VOLLEY Gen5 — computational evidence review

Fixed academic configuration and negative design findings

VOLLEY engineering record

9 October 2026

Figure 2. Calculated Gen5 magnetic field; this does not measure integrated thrust.

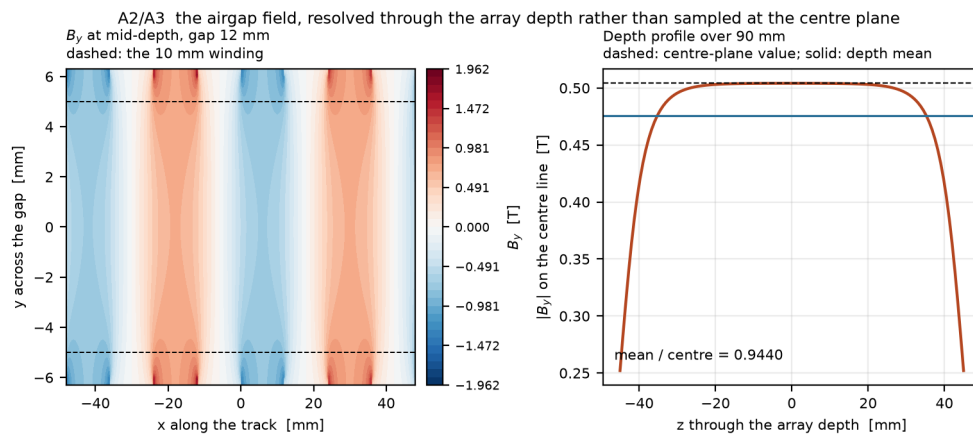
oscilloscope capture. The field plot is from the declared analytical field builder; separate 2-D and 3-D checks agree on *selected field quantities*, not on the complete depth-integrated thrust constant. Hot winding resistance, inverter switching, full bank supplier data and protection remain unresolved.

Figure 3. Independent two-body geometry response; sweep points are not a Gen5 command envelope.

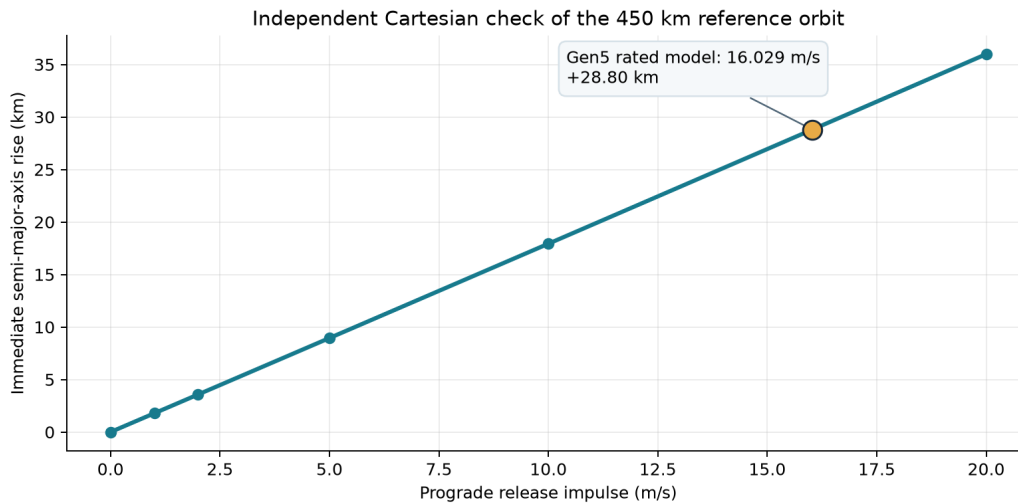
For a 450 km circular host reference, a 16.029 m/s instantaneous tangential impulse gives a **28.800775 km** semi-major-axis rise in the separate Cartesian DOP853 propagation. The two-body numerical band is 0.02 m and passes. This confirms immediate orbital geometry at the modeled release speed. It does not independently establish the stated **1.60 lifetime multiplier**, which depends on a static atmosphere at mean activity and has no current rated-case independent rerun. It does not establish thrust, finite release duration or host acceptability.

Figure 4. Dimension-derived cross-section and exact-solid clash. Reference placement, not a production drawing.

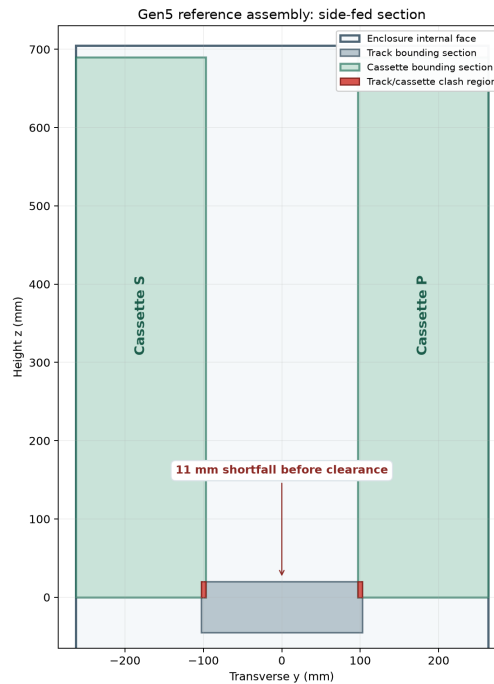
The FreeCAD 1.0 CAD review releases a native .FCStd document, eight FreeCAD-exported STEP parts and a 20-instance assembly STEP. The side-fed reference placement fails: 526 mm internal width versus 537 mm for track and cassettes before clearance. Both CadQuery and FreeCAD find **32,915 mm³** exact-solid track/cassette overlap per side. The clash is left in the native project for inspection. It may be remedied only by a new feeder/enclosure configuration and renewed analysis; the existing design cannot be called mechanically complete.
